LOT 5, RIZVI PROPERTY
ON-SITE SEWAGE DISPOSAL SYSTEM DESIGN PLAN
14945 OLD FREDERICK ROAD
WOODBINE, MD 21797
TAX#: 348885, SUB: 1001

Approved Septic System Plan
Howard County Health Department

LOT 5, RIZVI PROPERTY
ON-SITE SEWAGE DISPOSAL SYSTEM DESIGN PLAN
14945 OLD FREDERICK ROAD
WOODBINE, MD 21797
TAX#: 348885, SUB: 1001

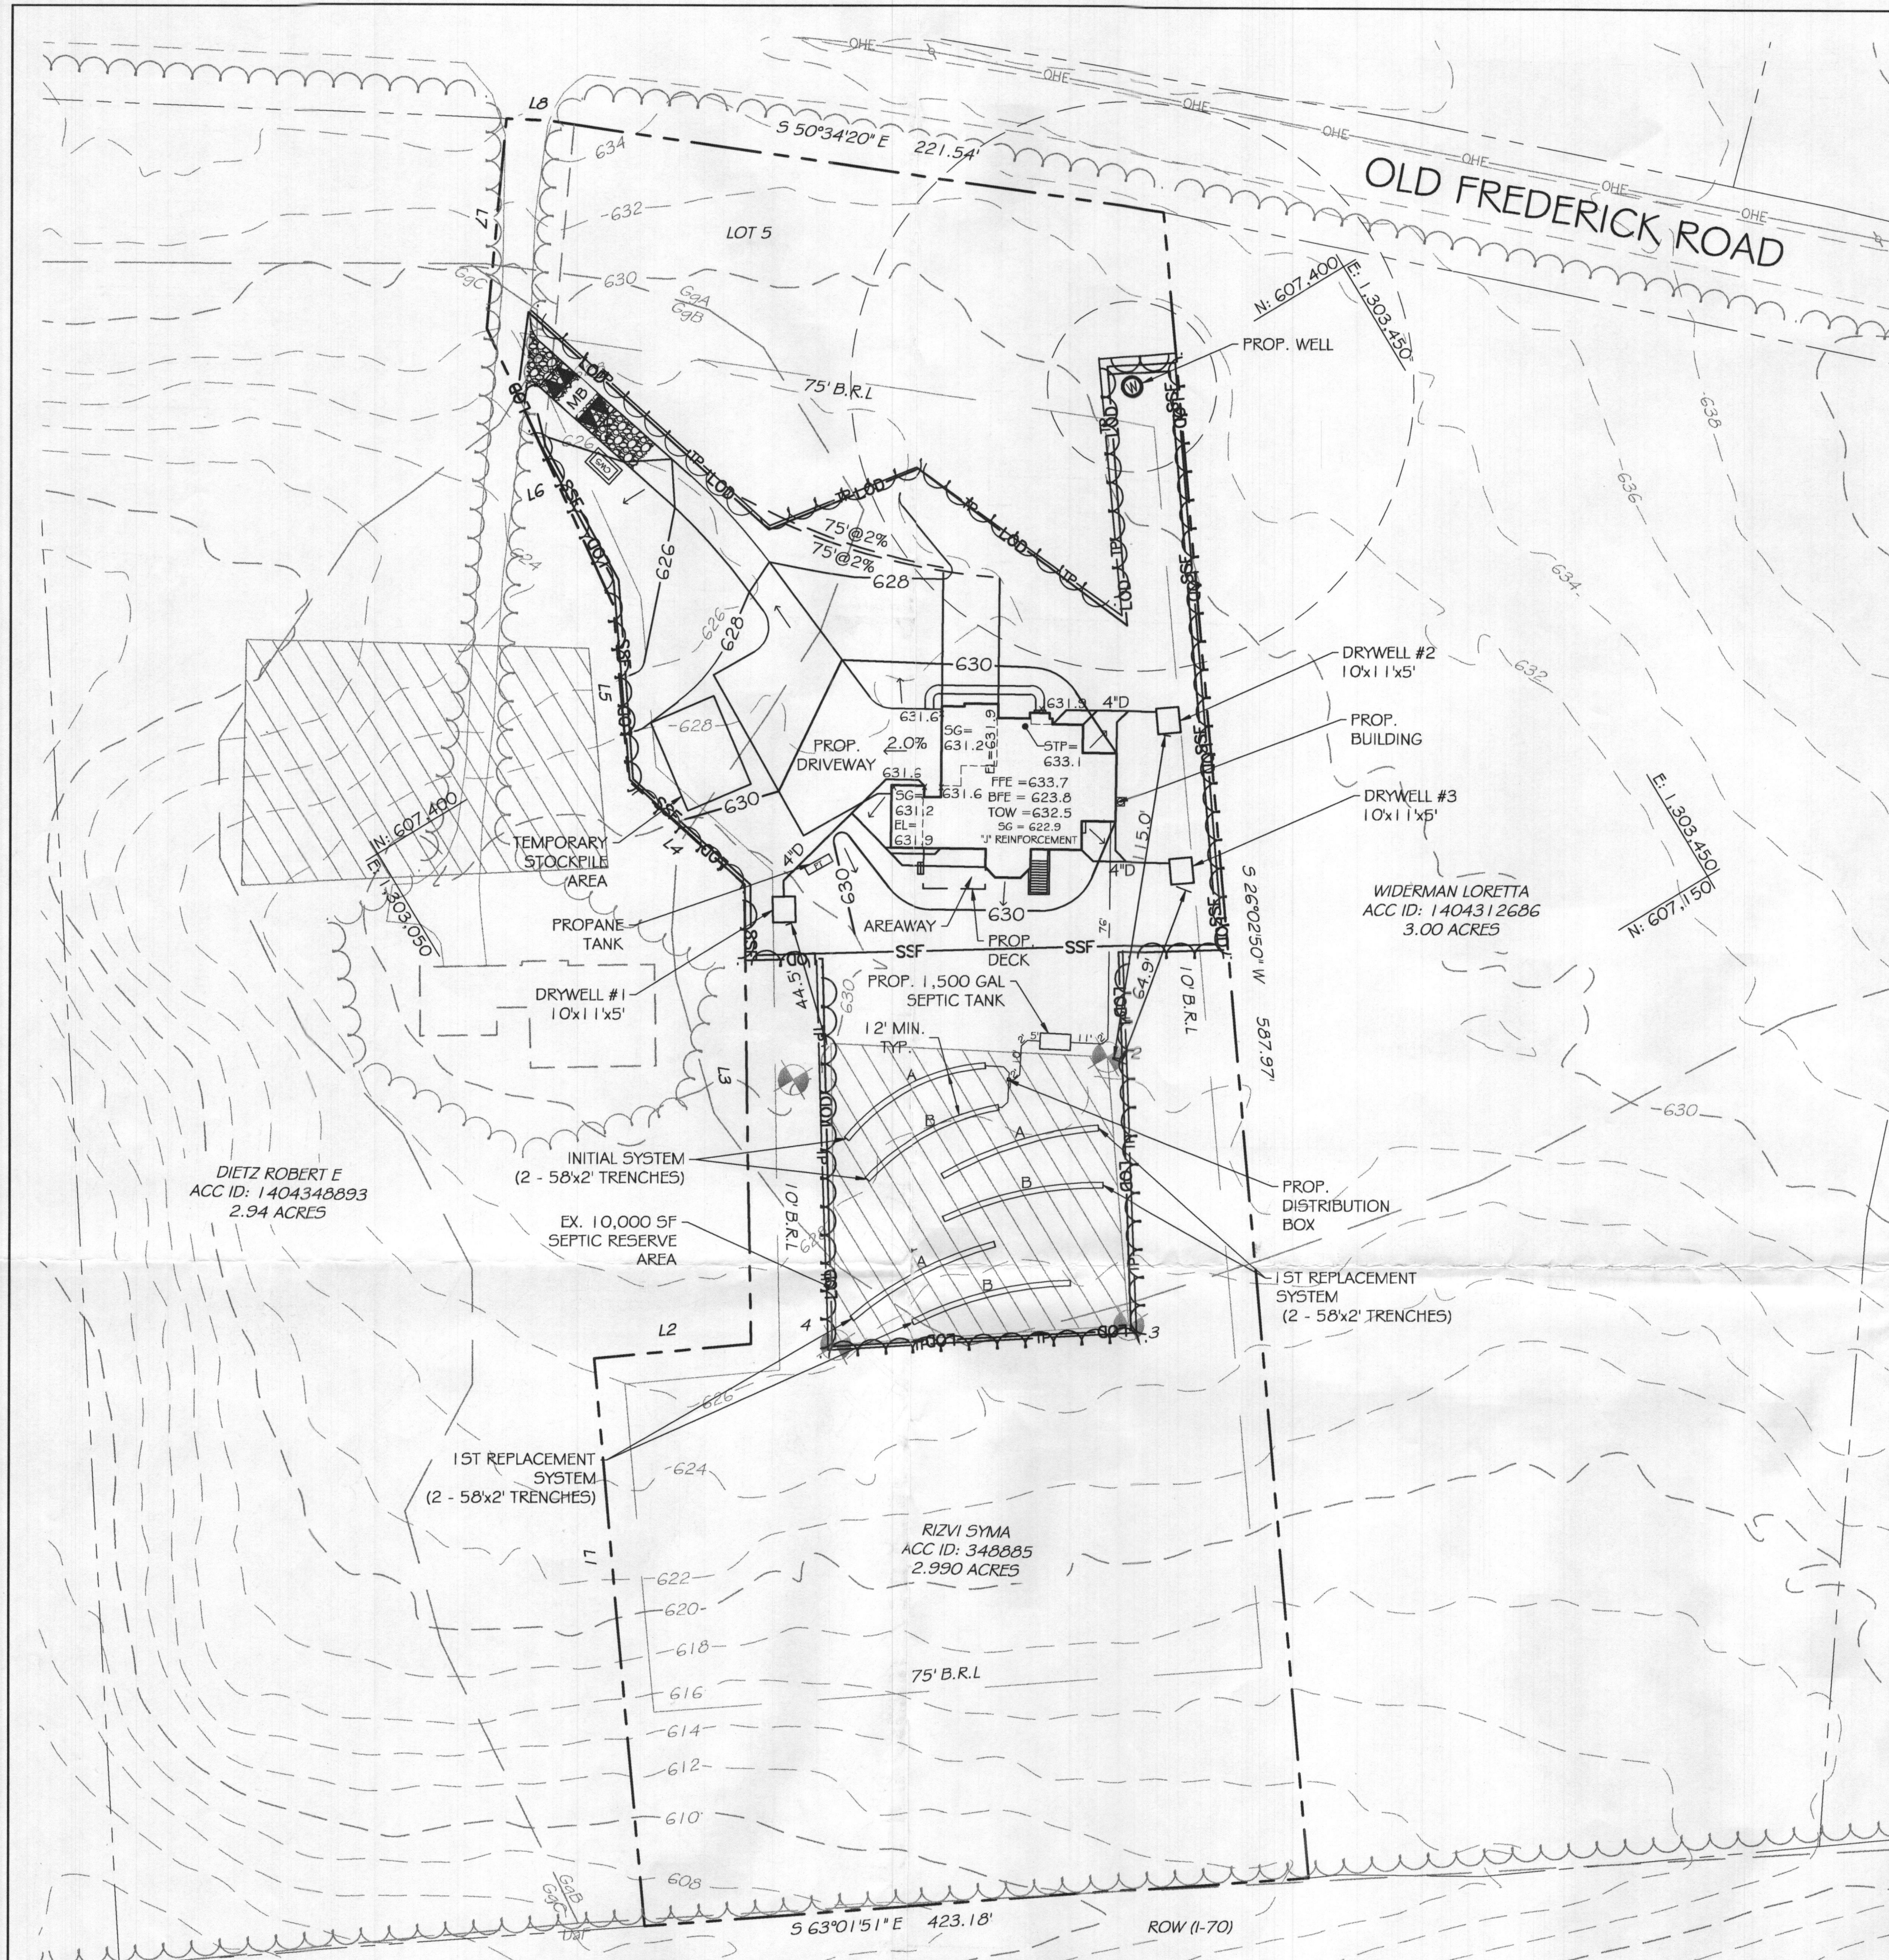
Revise. JB 1/31/22

LOT 5, RIZVI PROPERTY
ON-SITE SEWAGE DISPOSAL SYSTEM DESIGN PLAN
14945 OLD FREDERICK ROAD
WOODBINE, MD 21797
TAX#: 348885, SUB: 1001

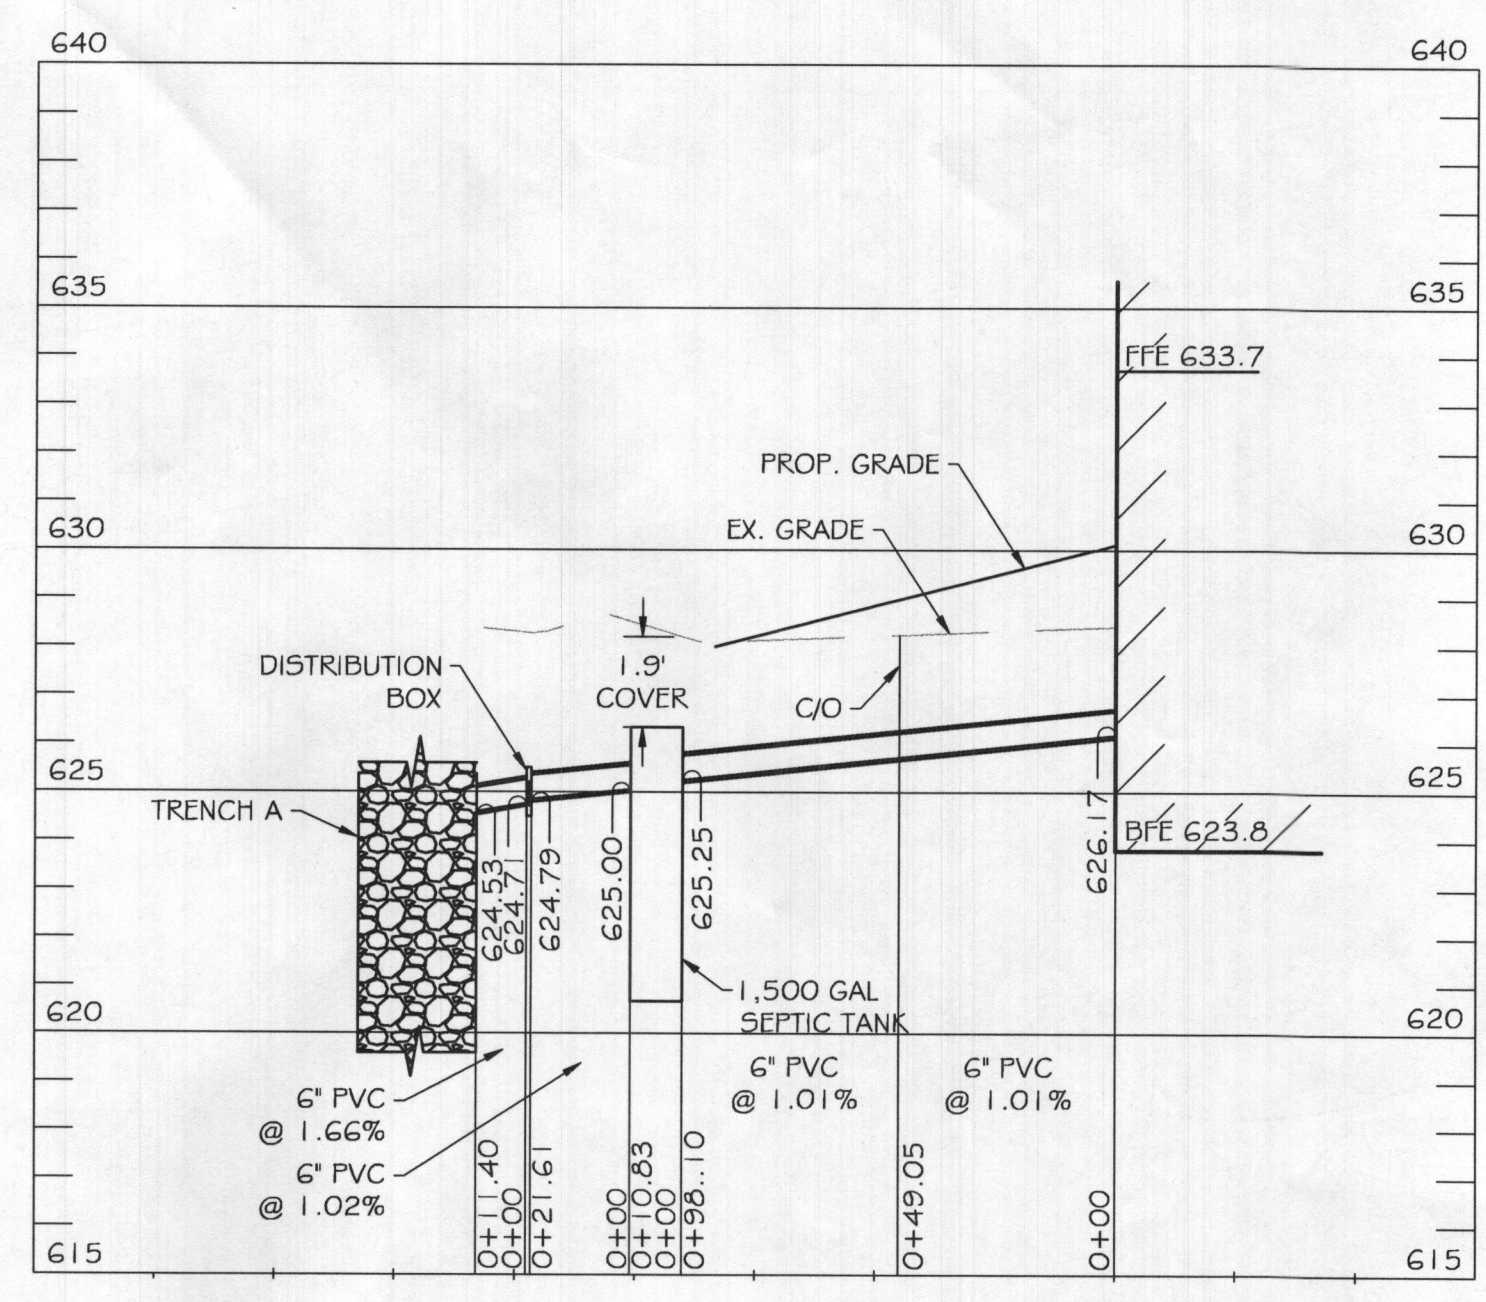
Revise.
gB 1/31/22
